Philips Radio Kommunikations Industri A/S (Copenhagen)

Concerning: **AP4000/AP6000**

This service deals with information to service manuals for AP4000 series and AP6000 series.

Concerning:	AP4007	91.01
-------------	--------	-------

Component location AP4009

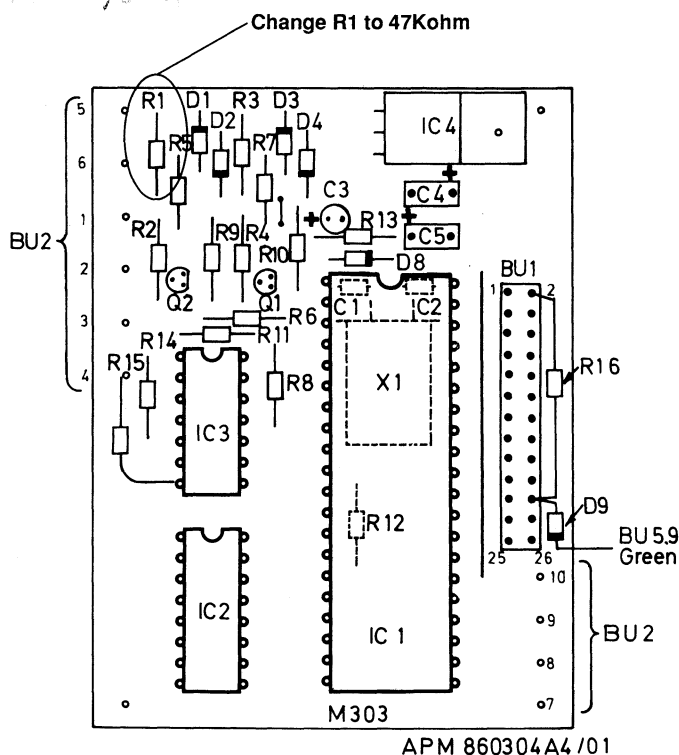
To improve the communication between service interface unit AP4009 (SIU) and connected radio telephones, you may change the resistor R1 in the SIU to 47Kohm (See drawings below).

Ordering number for resistor R1, 47Kohm: 4822 116 52472.

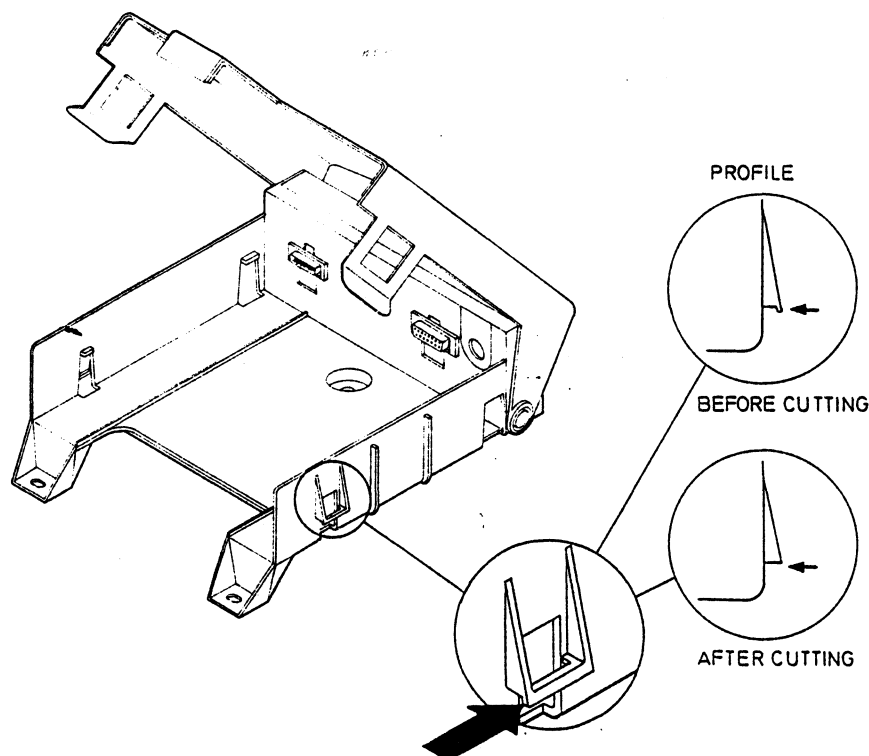
When changing software from version 2 to version 5, you must change the digit on the typeplate from 2 to 5. This is to be done by making a cross, by engraving, over the digit 2 and then making a digit 5, by engraving, in the next free area on the typeplate (see drawing below).

Mounting cassette AP4023/4024

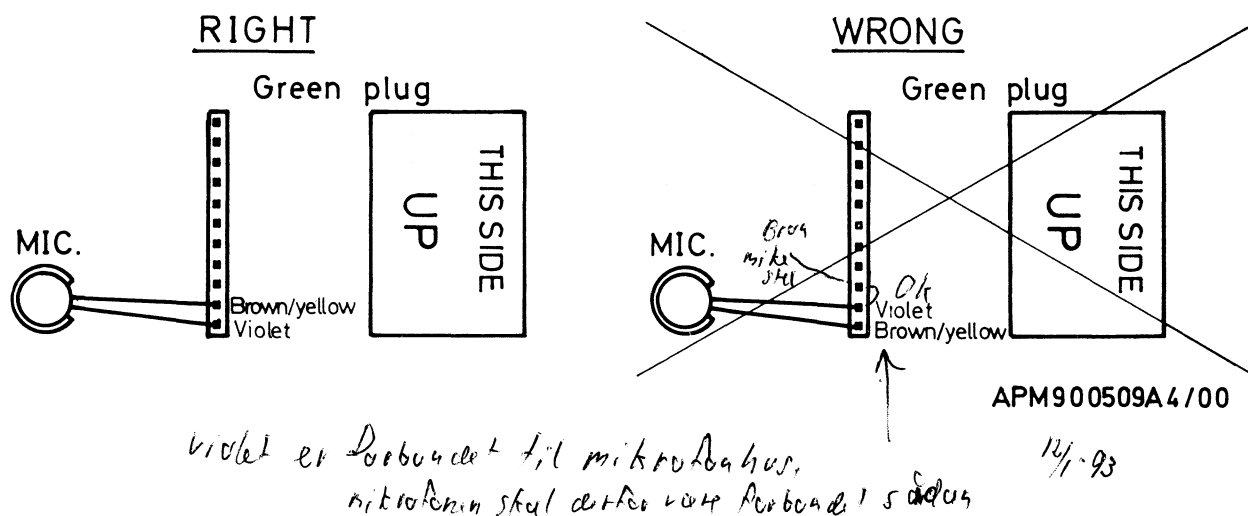
If the mounting cassette is mounted upside down e.g. under the dashboard it will be convenient to make a small modification on the cassette before it is mounted.

On the locking part of the cassette (both sides) is a small retaining rim at the edge (see detail on drawing below). Use a sharp instrument to remove these rims in order to avoid breaking the locking flaps on the lid when opening the cassette after the telephone has been installed.

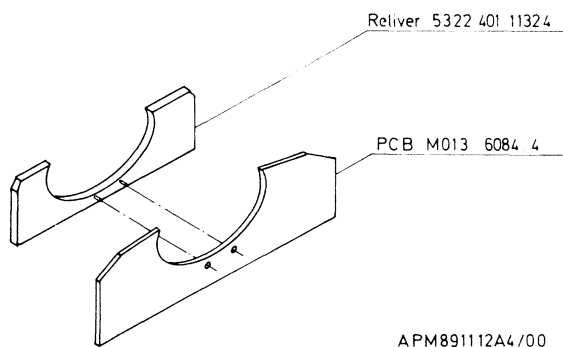
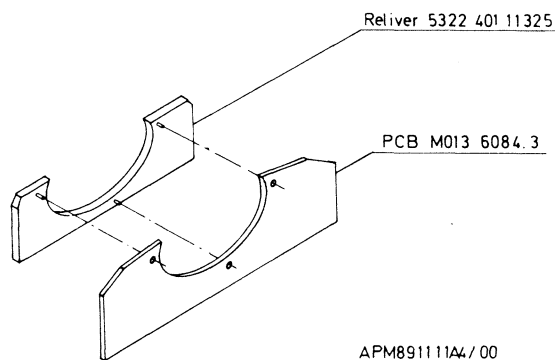
To avoid disconnection of wires on the PCB M013, please do as follows:

Mount the reliver, 12NC 5322 401 11325 for the old version version PCB M013 (printversion 6084.3) or reliver, 12NC 5322 401 11324 for the new version PCB M013 (printversion 6084.4).

Disconnect the wires and place the reliver on the PCB M013.

Keep the reliver close to the PCB and connect the wires to the PCB, by inserting the wires through the holes in the reliver and then connect/solder the wires to the PCB (see drawings below).

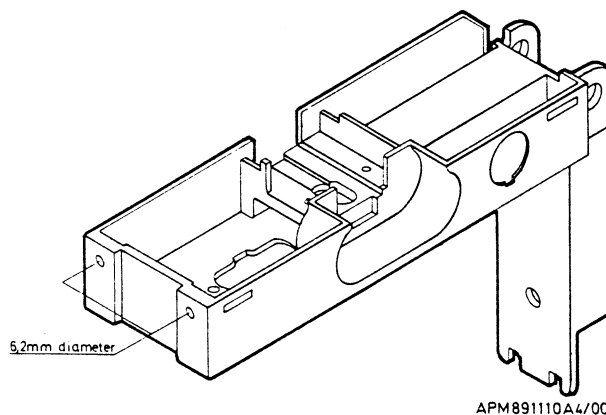
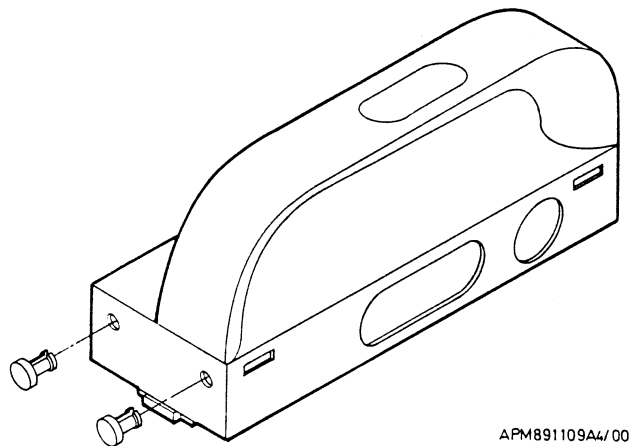
From ultimo october, the two screws 12NC 5322 502 21113 , and the two cap plugs 12NC 5322 462 41424 , will be replaced by two snaps 12NC 5322 417 50261.

The dimension of the two holes, for fastening the handle on the cassette angle, will be 6.2mm.

When inserting the snaps, be sure that the slot is located vertically (see drawing below).

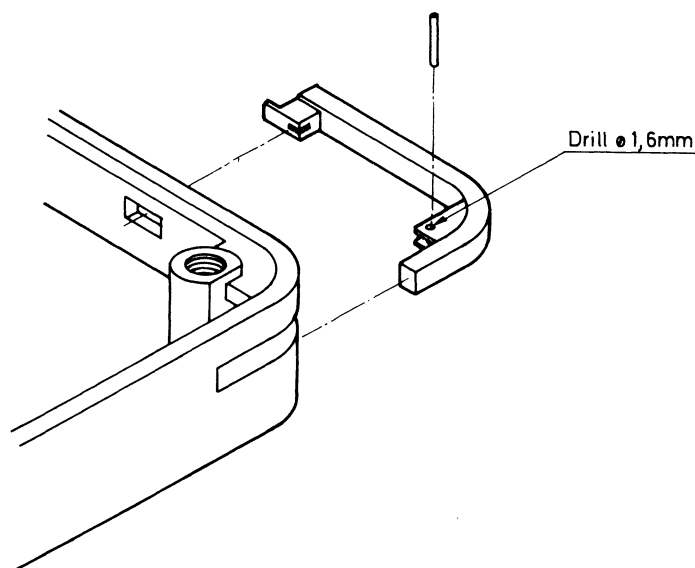
Ordering bottom part, 12 NC 5322 462 41465 , please notice that hole for fastening does not exist. That is quite normal !

The hole has to be made, when you are mounting the bottom part.

The reason for that is tolerances. If the hole are made in advance, there can be some cases where the bottom part will come loose after mounting on the frontpart.

1. Put the bottom part on the battery.
2. Make a mark on the bottom part as close as possible to the frontpart, inside.
3. Take away the bottom part and make a hole by drilling, diameter 1.6mm, where the mark have been maked.
4. Put the bottom part on the battery and fasten the bottom part with the clamp pin.

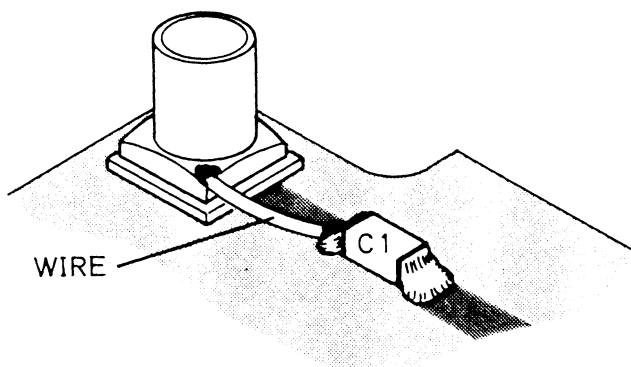
If the power amplifier is a SHWE 1065 control/verify the following:

On M260

C15 is removed.

C11 is a 6u8 capacitor. If not, replace the capacitor.

C9 is a 5p6 capacitor. If not, replace the capacitor.

At the MCX plug where the signal from the TX-module enters add 8mm of 0.3square mm tinned wire between the base of the MCX plug and C1 (see figure below).

Fig 1.

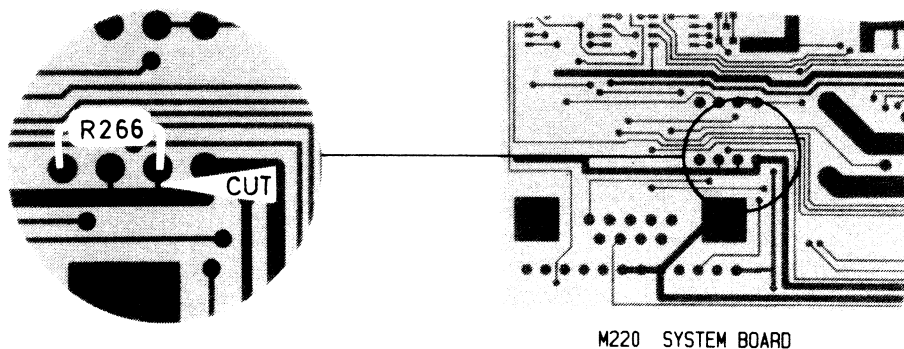
Lately two new types of EEPROM has been introduced on the systemboard, one marked CAT93C46PI or one marked CAT93C46API. Unfortunately the one marked CAT93C46PI will not work unless the following modification has been made on the systemboard:

Cut the print connection between IC218 pin 6 and ground, and add a resistor R266 between IC 218 pin 6 and pin 8.(See fig 1.)

R266 10 Ω 1/10W Ordering number 2322 180 73109

Figure 1.

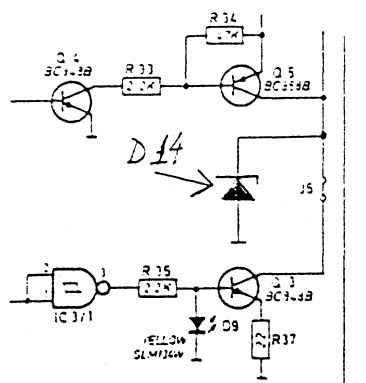
Problem : Q3 and Q5 on unit 1, the systemboard (M120 or M220) are defective due to inductive spikes from the relay RE1.

Solution: Connect a protective diode from the collectors of Q3 and Q5 to ground.

For M120 refer to figure 1.

The diode to be used is a BZX79-B24.

Figure 1.

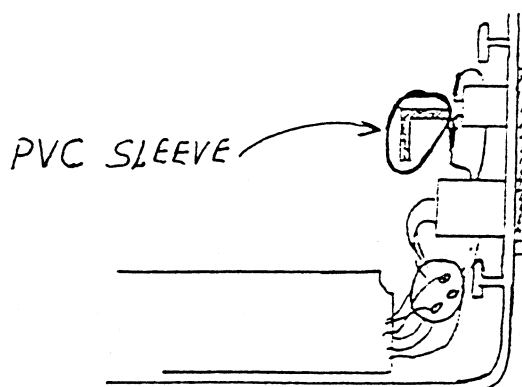
1. In battery packs produced before June 1988 a shortcircuit might occur between battery indicator LED D9 and ground. This shortcircuit will only cause damage when the battery is supplied from e.g. the car battery via the DC cigar lighter cable.

Cut a piece of PVC sleeve 2.5 centimeters, ordering number 0822 026 22235 (sold in meters), and slide the sleeve piece over the L-shaped terminal as shown on figure 1.

Figure 1.

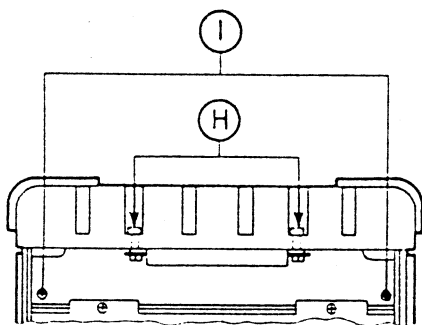
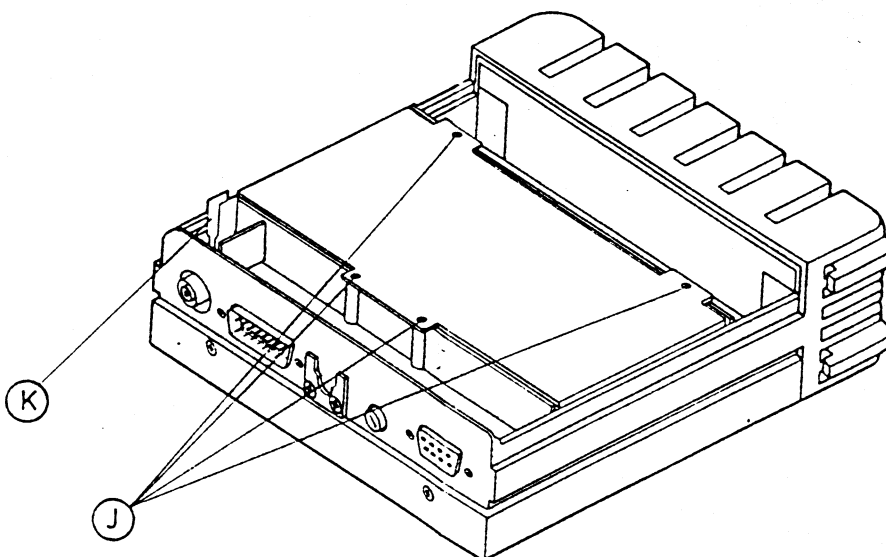
Fieldtest have shown that the PA-module and the Duplex-filter might come loose as time passes.

We therefore strongly recommend that, when a telephone is handed in for service, the screws holding both modules in question are tightened.

For AP 4xxx see items H, I, J, on figures below.

Fig. 1

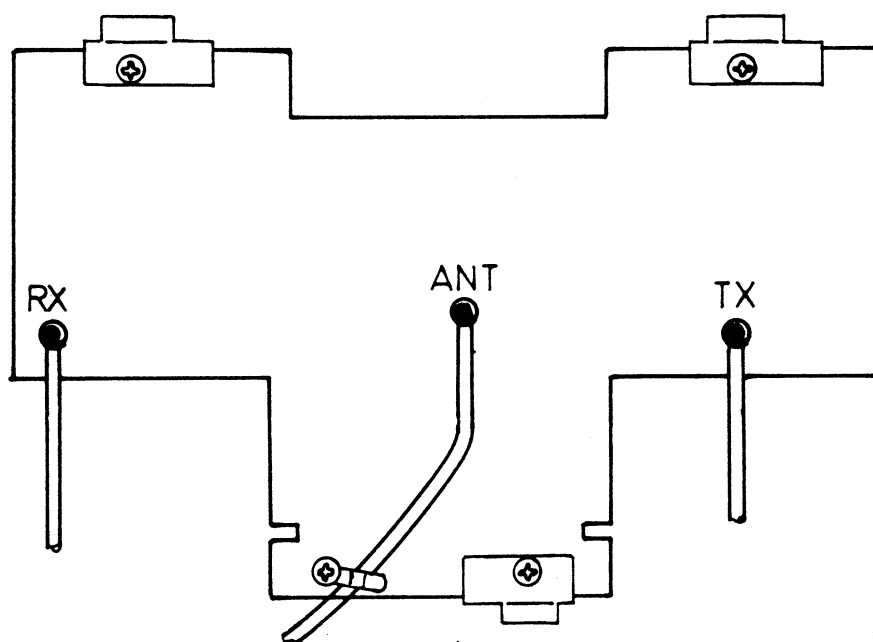
Fault : In some cases the coax cable on the duplex filter may touch the cover of the transceiver.

Repair : Please mount a soldertag, ordering number: 3508 100 46210, on the duplex filter placed as shown on fig. 1.

Hold down the coax cable with the soldertag and make sure that the cable does not touch the transceiver cover.

Fig. 1 Handset horizontal right, vertical

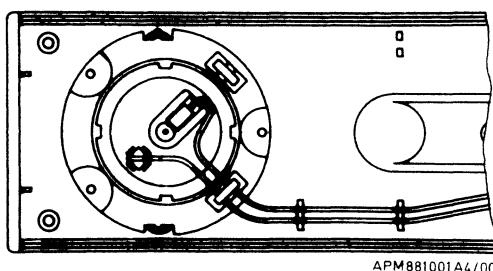
A new type of earpiece suspension is designed for the handset to improve the sound in the earpiece loudspeaker. If the suspension is changed to the new type, it is also necessary to change the reflector screen cloth disk, holder and the three Quick-lock rings.

IMPORTANT: Fig. 1 and fig. 2 show how to place the earpiece loudspeaker connections.

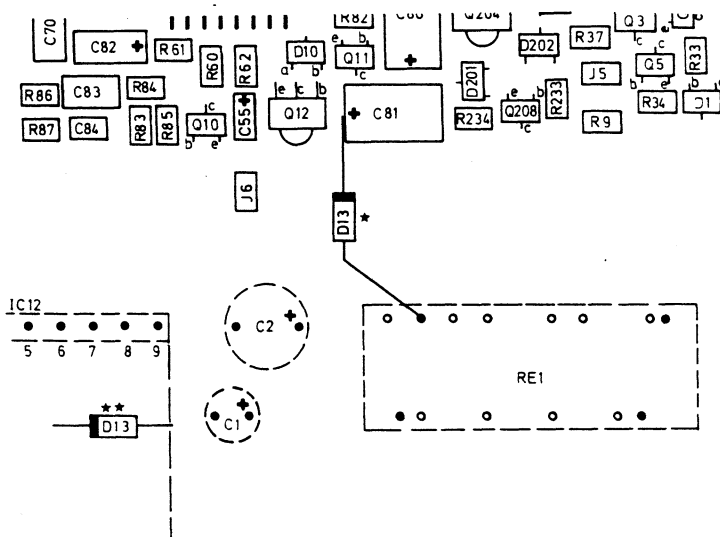
This service information concerns the system board unit 1 in the transceiver.
The factory has recently introduced some improvements in the power supply part.

The diode D13 (1N4001), ordering number 9330 630 30113, has been mounted as shown on the figures below and the diode D10 has been changed to a new type diode (BAW56), ordering number 9330 989 90215.

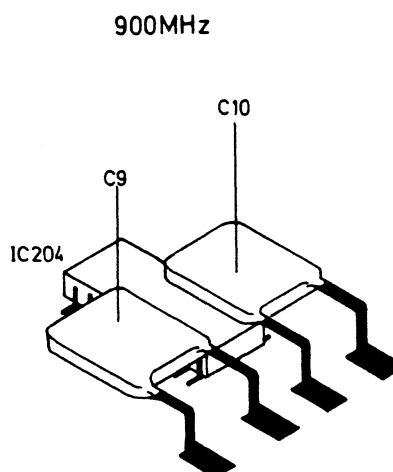
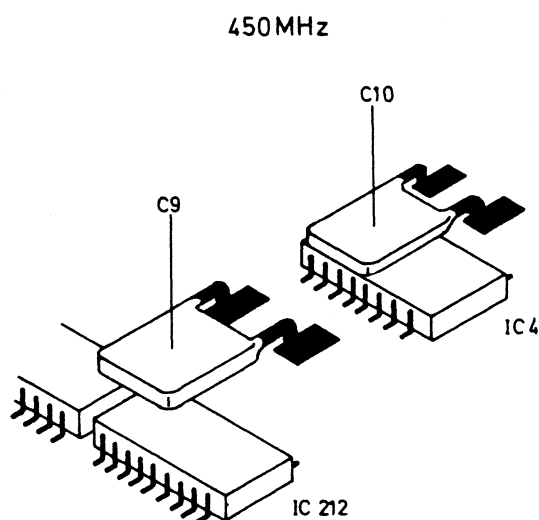
Fault : The mobile telephone switches itself off or may fail in the start-up procedure.

Troubleshooting: The capacitors C9 and C10 on the system board, unit 1, fails.

Repair : Remove the two SMD capacitors.

Clean the surface underneath the capacitors for solder and flux remnants.

Mount two new capacitors of the type 3508 100 31250 (270N) as shown on the figure.

Alternatively it is possible to use type 3508 100 31240 (220N) or type 3508 100 31260 (330N), but the two capacitors (C9/C10) must always be of equal value.

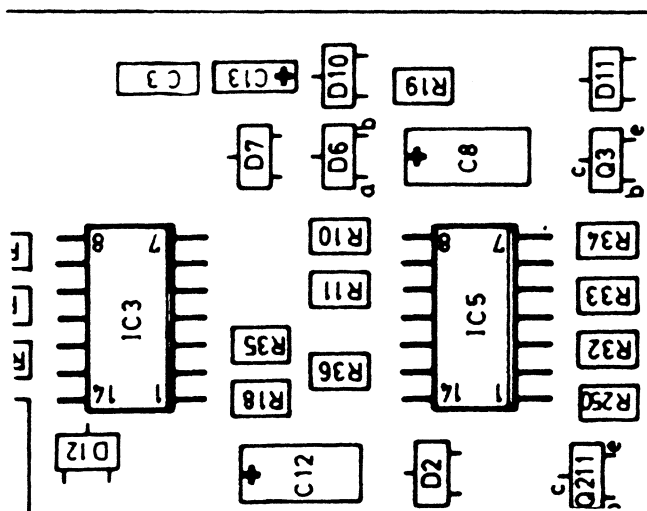
Fault : C13 on the system board unit may break down or short circuit in some earlier production series.

Troubleshooting: A diode D10 is mounted across R19 in some earlier production series. This causes to high voltage on the capacitor C13.

Repair : Remove D10 (and shift C13).

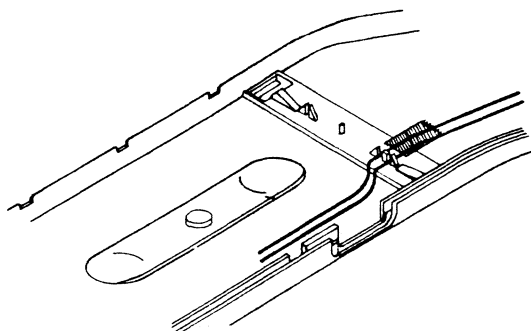
1. Fault : ON/OFF circuit fails.

Troubleshooting: Small pieces of solder waste may be left around or under C9 and C10 on the systemboard, unit 1.

Repair : Remove C9 and C10 and clean both the print and the bottom part of the capacitors for solder and flux remnants. Replace the capacitors.

Fig. 1 Old type

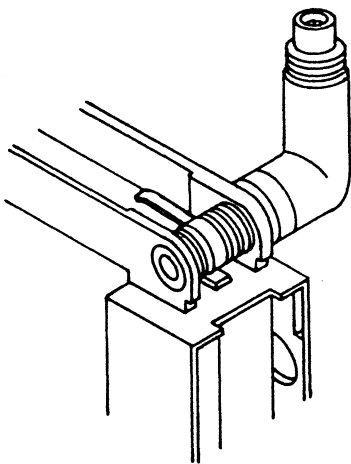
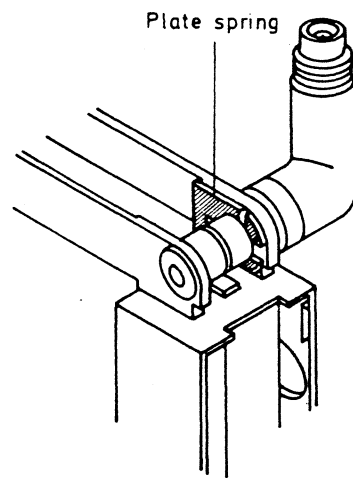
The plate spring is now included also when the antenna angle (8208 244 00111) is ordered.

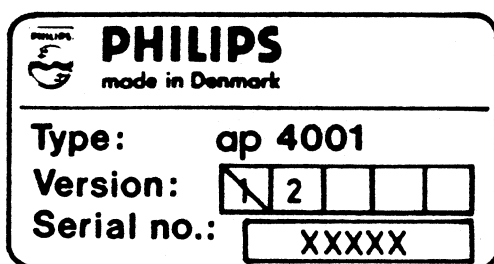
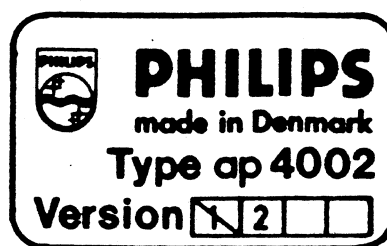
Hvis version 1 batteripakke eller bærbart kit modificeres til version 2, skal typeskiltet korrigeres som vist på nedenstående tegning.
